**FORD:**

2015 F-150

**ISSUE**

Some 2015 F-150 SuperCrew vehicles built on or before 4/27/2015 and equipped with a rear seat center armrest may exhibit a concern where the armrest does not stow flush with the rear seat back.

Figure 1 - Article 15-0080

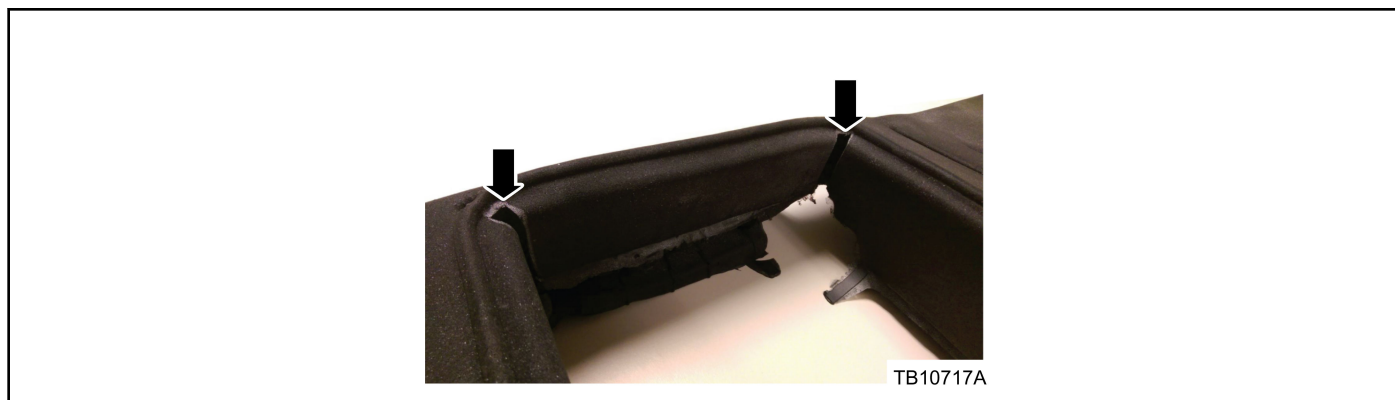
1. Inspect the rear seat center armrest to be sure the stowage pocket is clear of obstructions and verify the concern.
2. Remove the left hand (LH) rear seat backrest cover and foam pad. Refer to the Workshop Manual (WSM), Section 501-10.
3. Using a razor blade or similar tool cut two 10 mm x 10 mm x 100 mm (13/32" x 13/32" x 4") trenches into both upper corners of the armrest pocket in the rear seat backrest foam pad. (Figure 1)

- a. Do not cut into the surrounding foam bead.
4. Replace the LH rear seat backrest cover with the latest level service part, reusing the modified foam pad. Refer to the WSM, Section 501-10.
